Change Notice Information Announcement

Product Name(s):	Aux Contacts for DP Contactors	Customer Support No.	1(847) 441-2540
Product Line Description:	Definite Purpose Contactors	Document Issued:	04/26/2021

9999DD11 (being obsoleted on left)

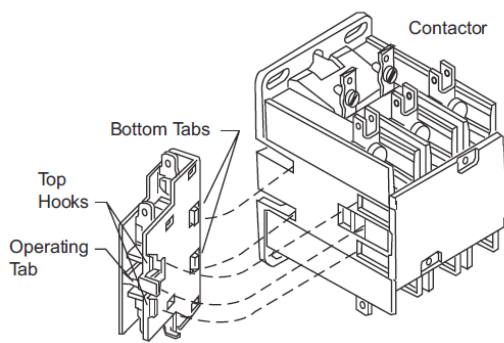
A decision has been made to only carry one Aux contact for DP Contactors. Today we have two different versions, which are allowed on the entire DP Offer from 20- 90A and perform the same identical function. The 9999 DD** series Aux contact is obsoleted, and the 9999 D** series aux contact will be the only version sold. The 9999 D** series was found to be more Robust.

9999D11 Still active on Right.
